**Re: Edgar P. Mills Multi-Purpose Center – Parking Garage
Broward County, Florida**

NOTICE OF CLAIM PURSUANT TO CHAPTER 558, FLORIDA STATUTES

Re – Edgar Mills Complex – Parking Garage, 900 NW 31st Avenue, Fort Lauderdale, FL:

Observed crack at a second-floor joist support – Field Report:

Exhibit 1: Cracked Haunch below third floor joist.

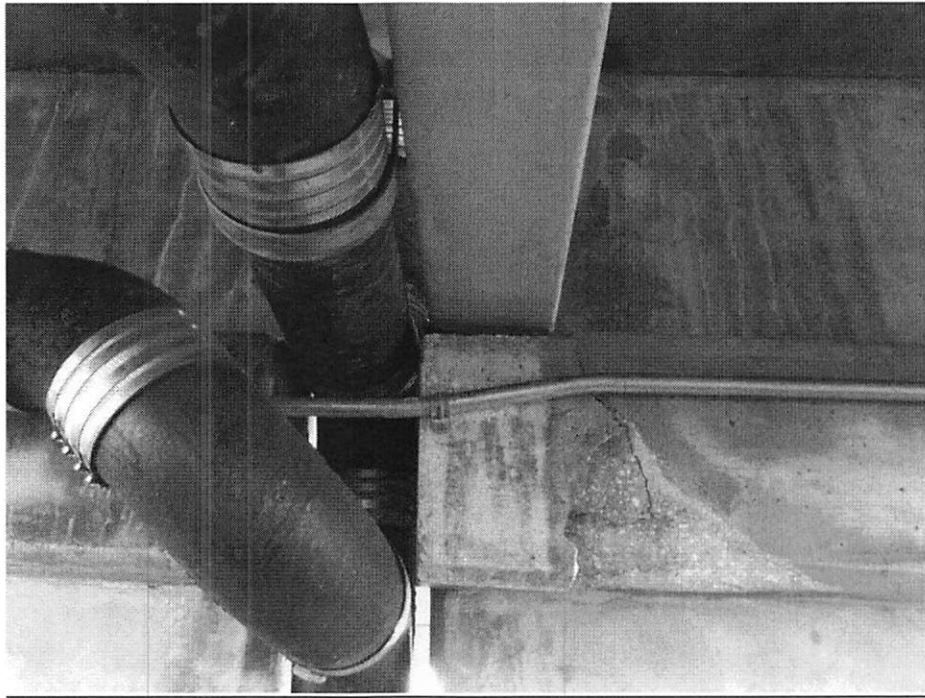
- 2) Second-Floor Haunch Crack: Below the West end of a third-floor joist (8th joist counting from the South Entrance) on the East wing of the garage, supporting haunch has failed as shown in the attached exhibits 1 through 4. Currently only the back end of the haunch may be providing any support to this joist. There is no bearing of the joist toward the face of the haunch as shown on exhibits 10 and 11. This joist is currently supported with temporary shoring extending to the ground floor slab as shown on exhibits 4 to 8. The Garage is currently closed, and no vehicles are parked inside.

The failed third floor haunch is at the edge of a concrete wall panel. We can see that the longitudinal rebar and the stirrups are located too far inside the haunch, with about 3" concrete cover. It is important to locate the reinforcing close to the face of the haunch to prevent the unreinforced concrete along the edges to fail in shear. This is exacerbated by the fact that at this location, the joist is supported at the end of the haunch. This creates a situation where the haunch is in single shear versus the typical condition of double shear, essentially reducing the shear capacity by half. We believe that these are the possible causes for the shear failure observed.

Exhibit 9: Condition where a third floor joist is at the edge of a haunch. Shoring is required here.

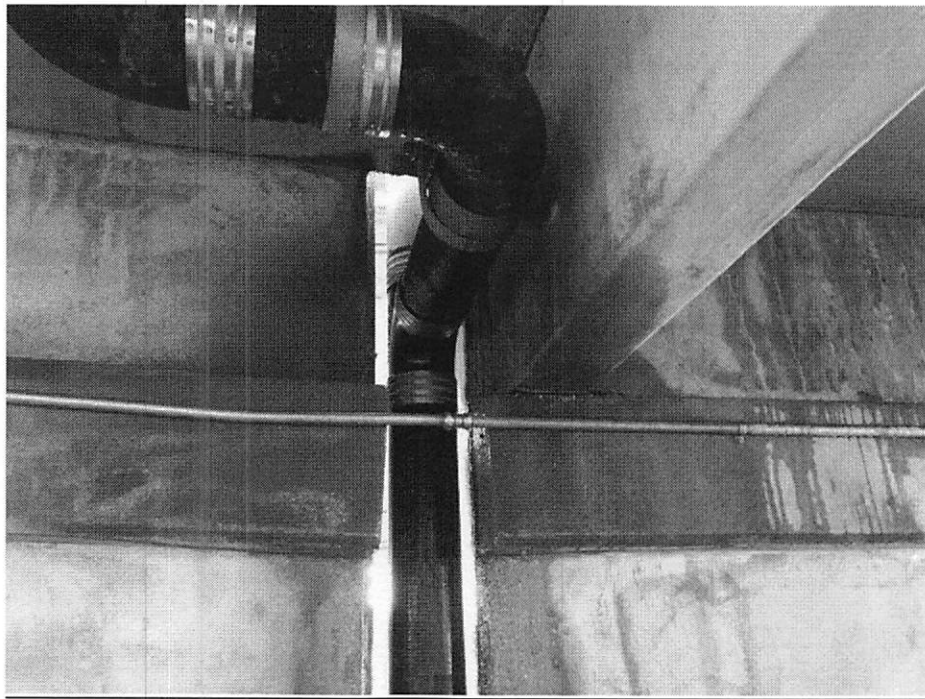
We believe that the installed shoring below the third-floor joist, continuous to the ground floor is adequate to temporarily support this joist at the cracked haunch. We recommend similar shoring at a similar condition which is occurring on the second joist to the North of the cracked haunch as shown on exhibit 9.

Exhibit 12: Spalled face of a haunch below a supported joist.

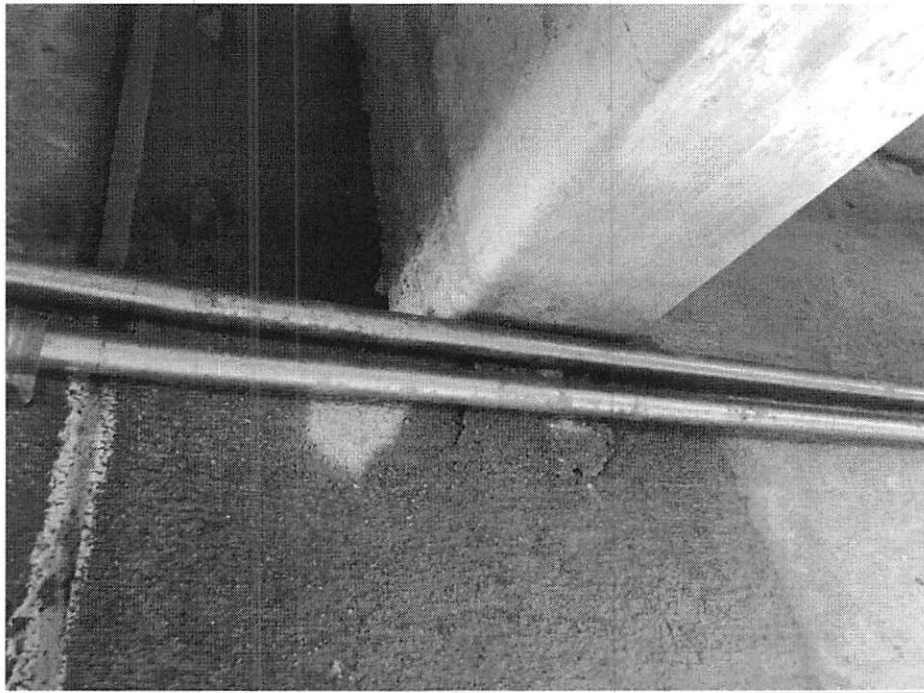
- 3) Cracks and Spalls on the face of haunches at other locations: We observed cracks and spalling on the face of haunches at other locations as shown on exhibits 12 to 14. These are occurring primarily below the roof joists.

We believe that the relatively smaller spalling and cracking at the faces of the haunches at other locations are due to the flexing of the joists up and down due to the temperature variations which are more severe for the joists below the exposed roof slabs.

We believe that the garage can be opened after installing this shoring and protective barricade around the shoring. This shall be followed by a complete review of the structural drawings and permanent repairs of the observed spalling and cracking at the haunches, soffit beams and slabs.

Exhibit 16: Spalling and Cracking on a soffit beam at a joist support.

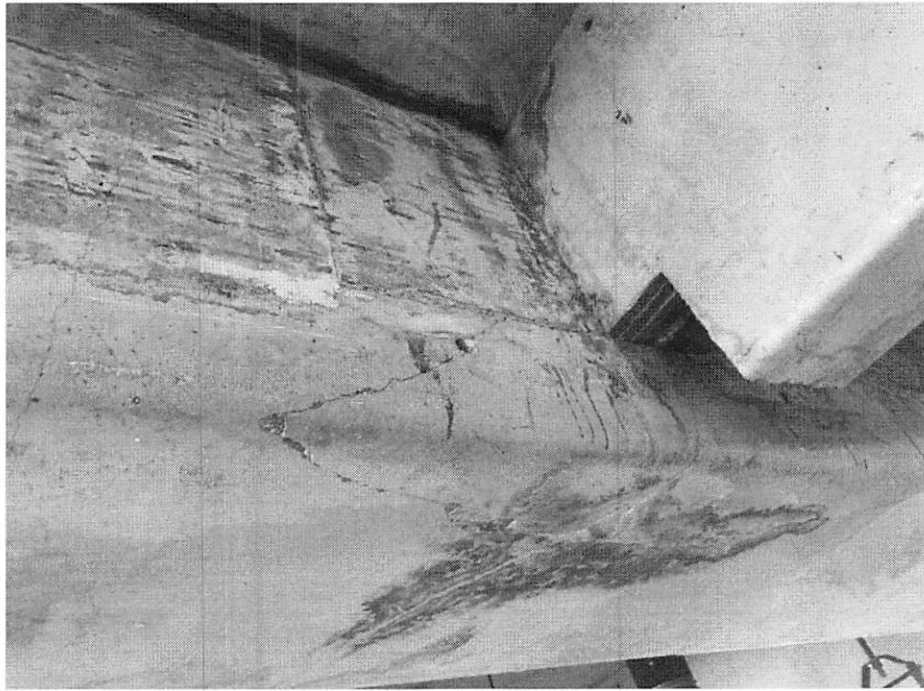
- 4) Cracks on Soffit Beams: Cracks are found on the soffit beams at the North end and South end as shown in the exhibits 15 to 17. Cracks are vertical cracks and diagonal cracks and also cracking below supported joists.

We believe that the soffit beam cracks below the supported joists are due to the flexing of the joists up and down due to the temperature variations which are more severe for the joists below the exposed roof slabs. Other vertical and diagonal cracks appear to be stress cracks due to the applied loading.

Exhibit 19: Slab cracks along the sides of a soffit beam.

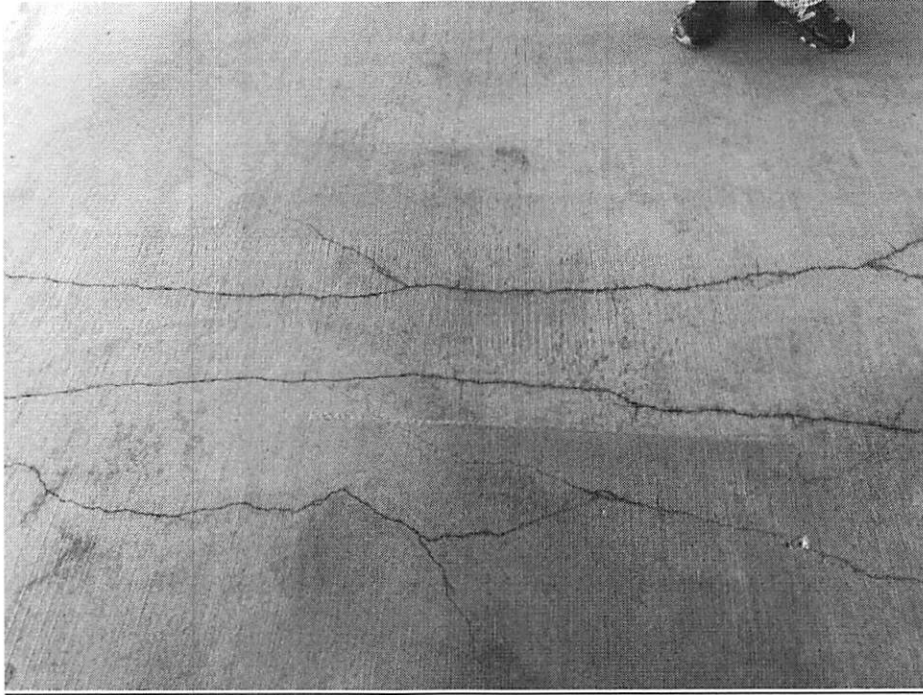
- 5) Concrete Slab Cracks: There are widespread cracking on concrete slab. Cracks are also noted along the top of soffit beams as shown on exhibits 18 to 20.

Topping slab has widespread cracks as noted above. It appears that these are primarily shrinkage cracks. We also observed cracks due to negative moments along the top of soffit beams.
